# Belgrove House

## DAS Addendum: Summary of Amendments

March 2022

### 2.3 Main Entrance - Euston Road

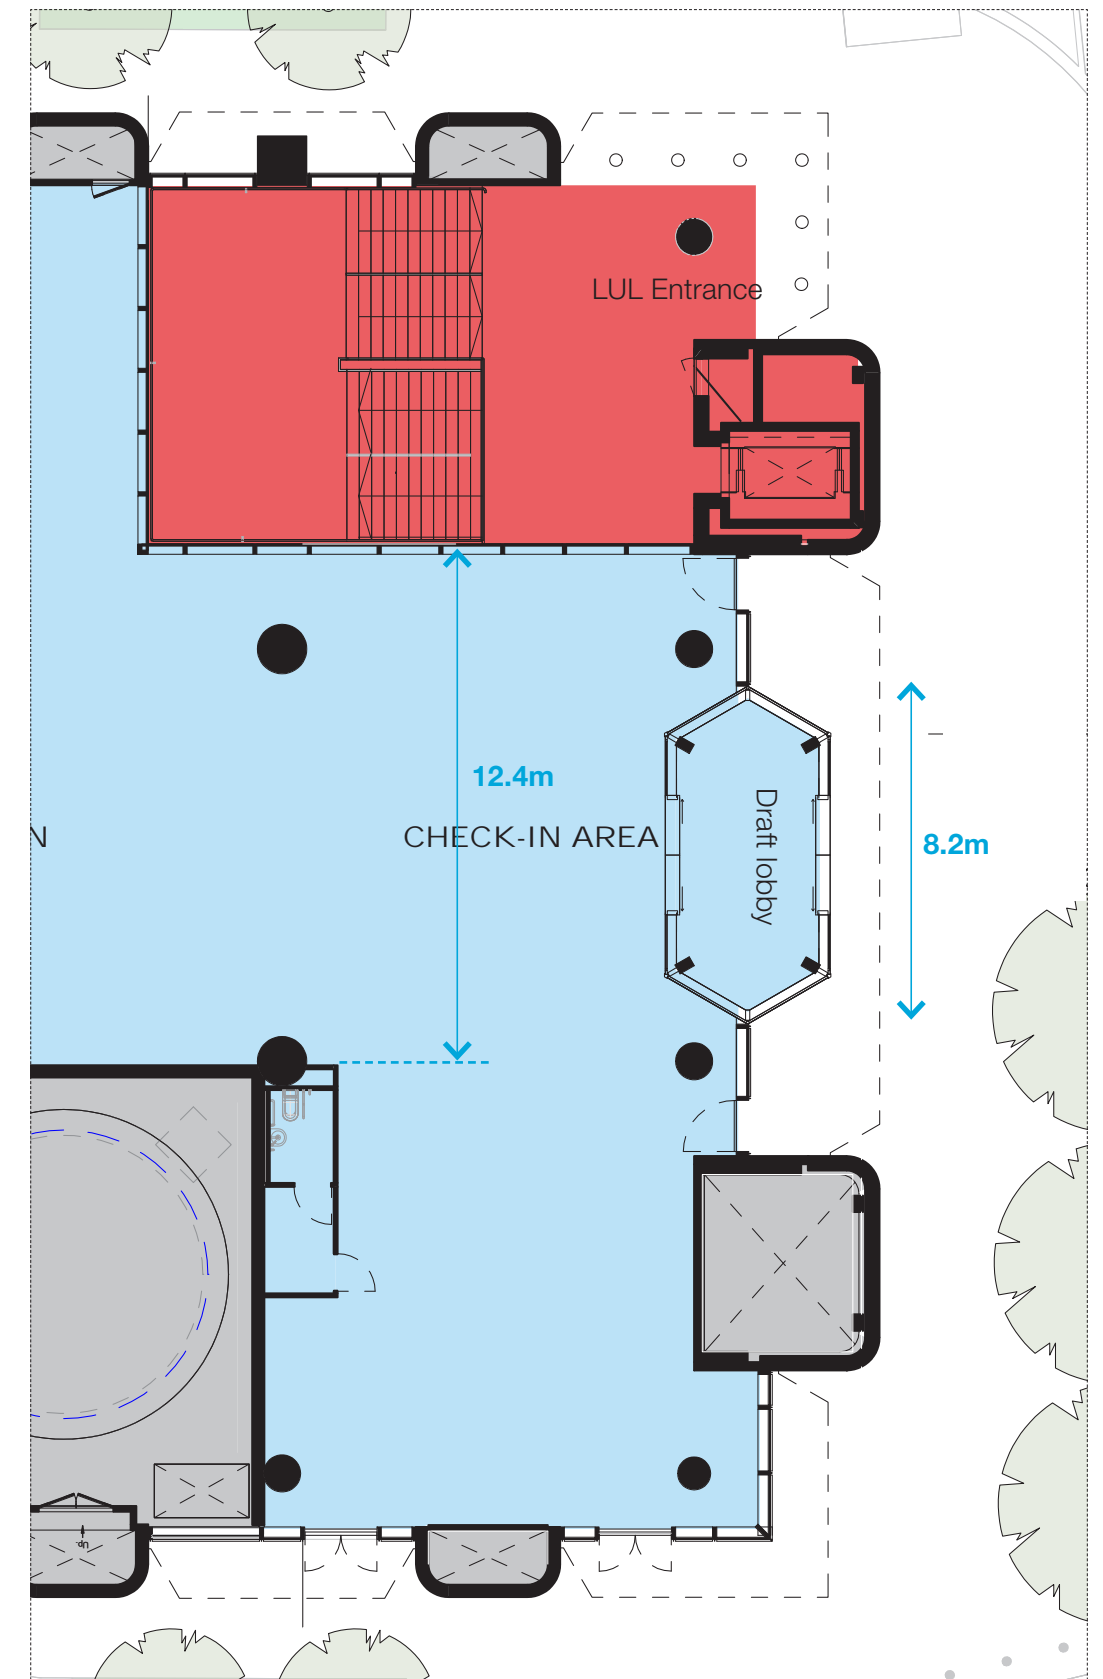
In the proposed design, a reconfiguration of the flexible retail and office area provides a generous entrance space in the proposed design as shown opposite. This area was indicated as 'retail' in the approved scheme.

A draft lobby is provided in the proposed design. It is anticipated that access will be via powered sliding doors. Planting will be incorporated within the enclosure, providing an enjoyable view from the street.

In the proposed design pass doors will be located on either side of the entrance in addition.

Recessing the whole glazed portion of the ground floor back from the facade line will provide Belgrove House with an inviting and generous civic presence when viewed from the Euston Road footpath.

## 3.1 Indicative use within flexible retail and office area

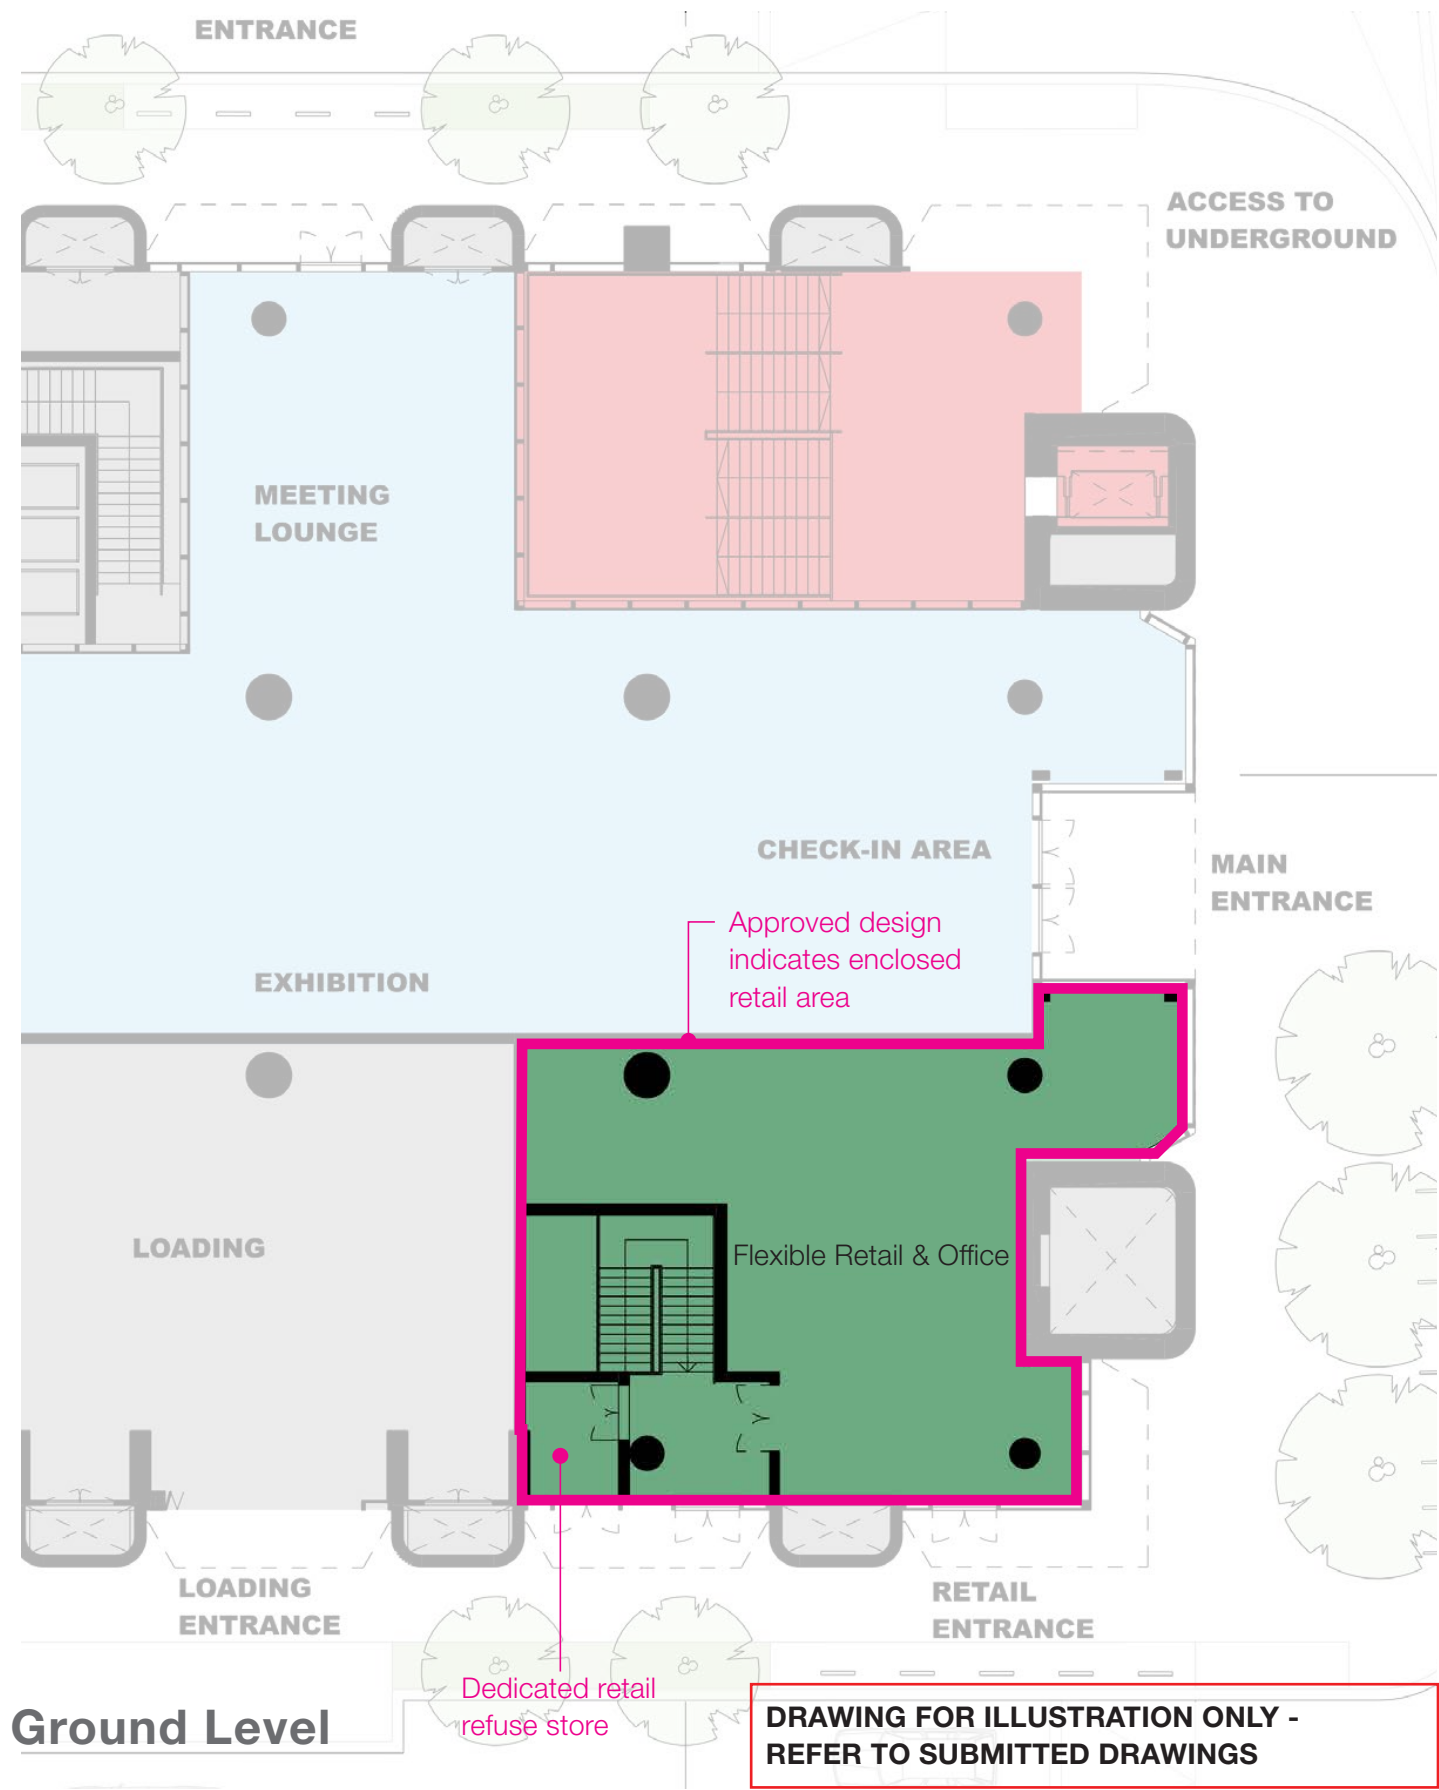
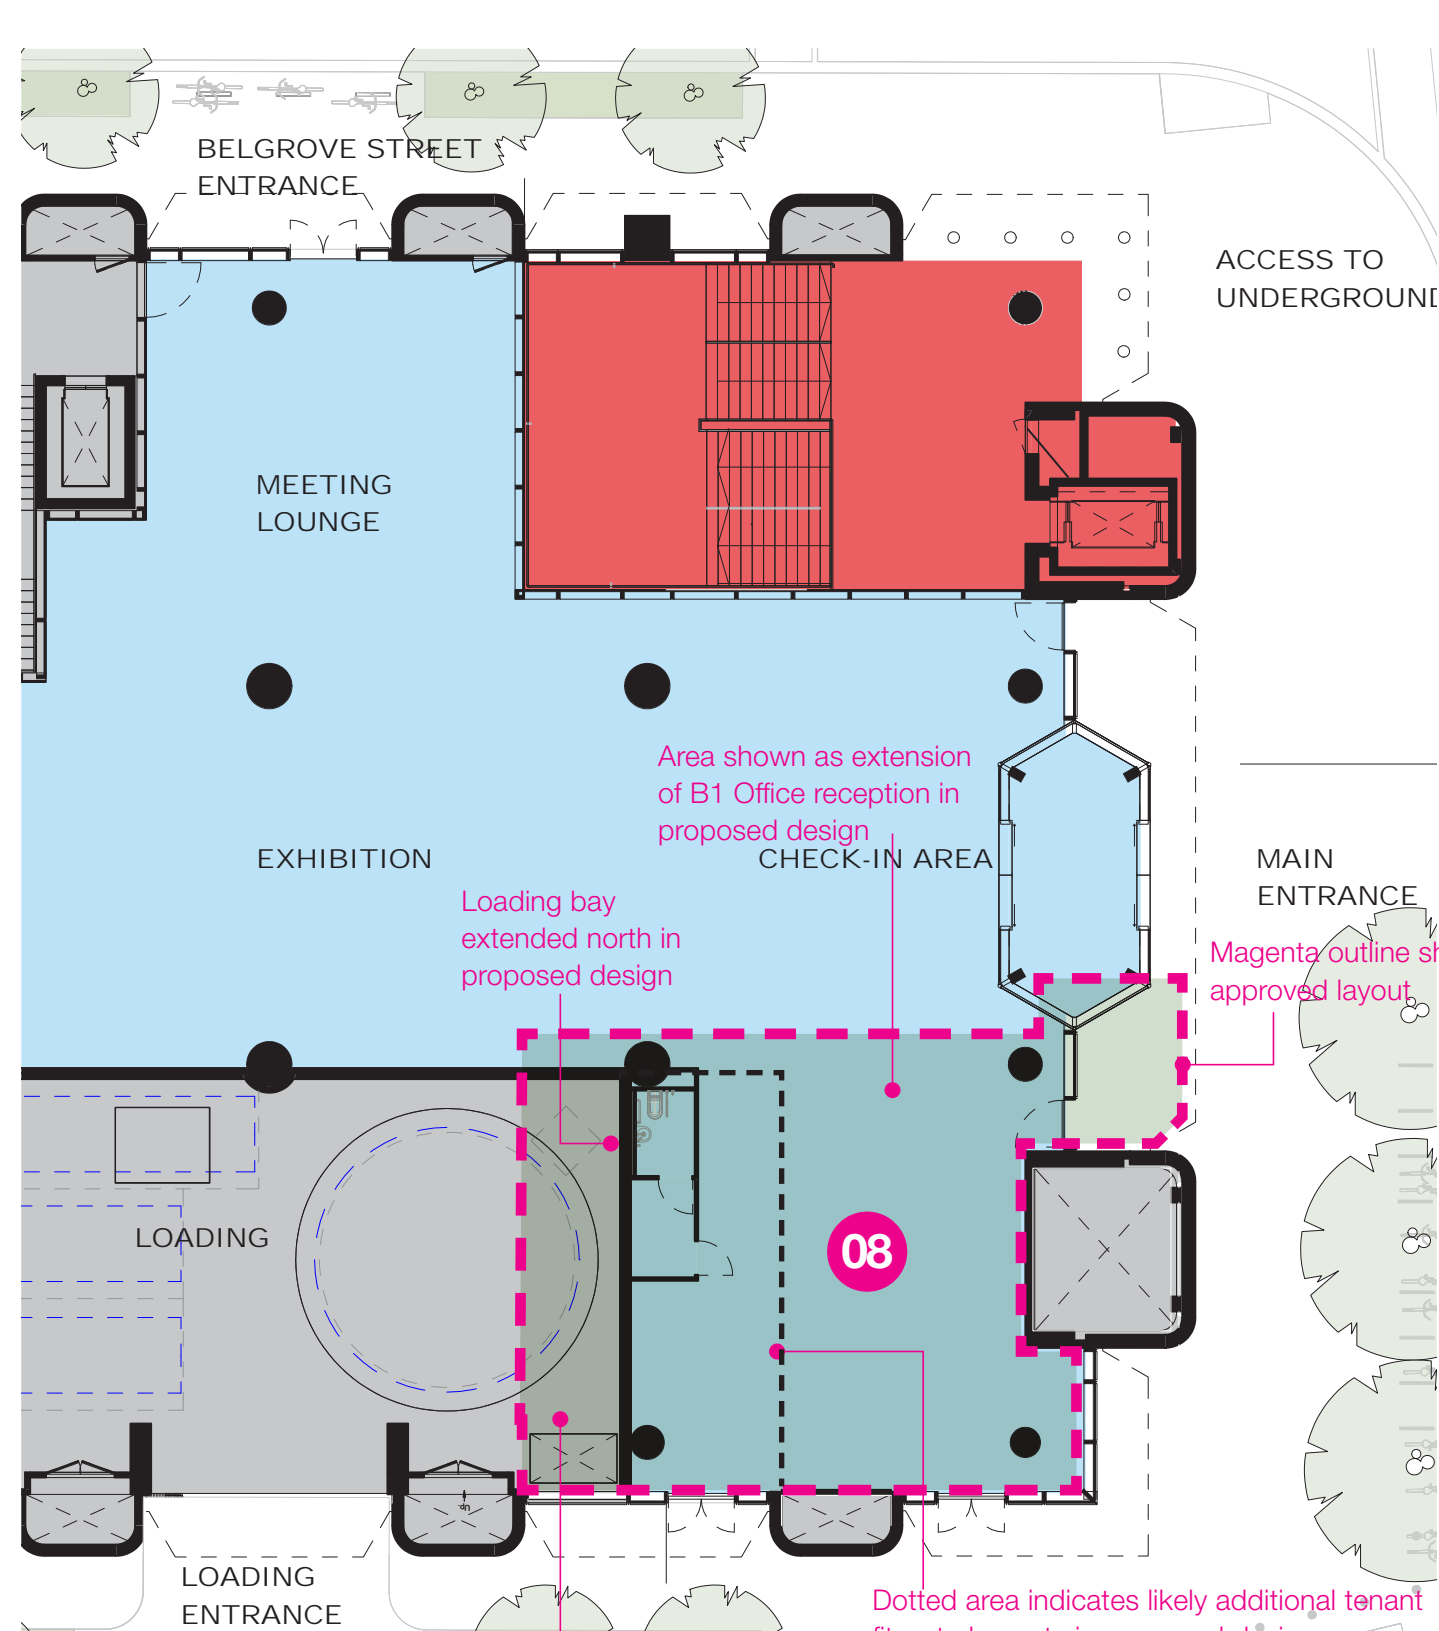
**Change of indicative use shown within ‘flexible retail and office area’**  
The indicative retail use (green) shown in approved drawings has been omitted and changed to B1 office (blue) at ground level in support of main entrance amendments and limited increase of the loading bay footprint. The linked lower-ground level of the retail unit has been allocated to B1 use (ancilliary grey) for the relocated cycle store - refer also to item 8 in this summary.
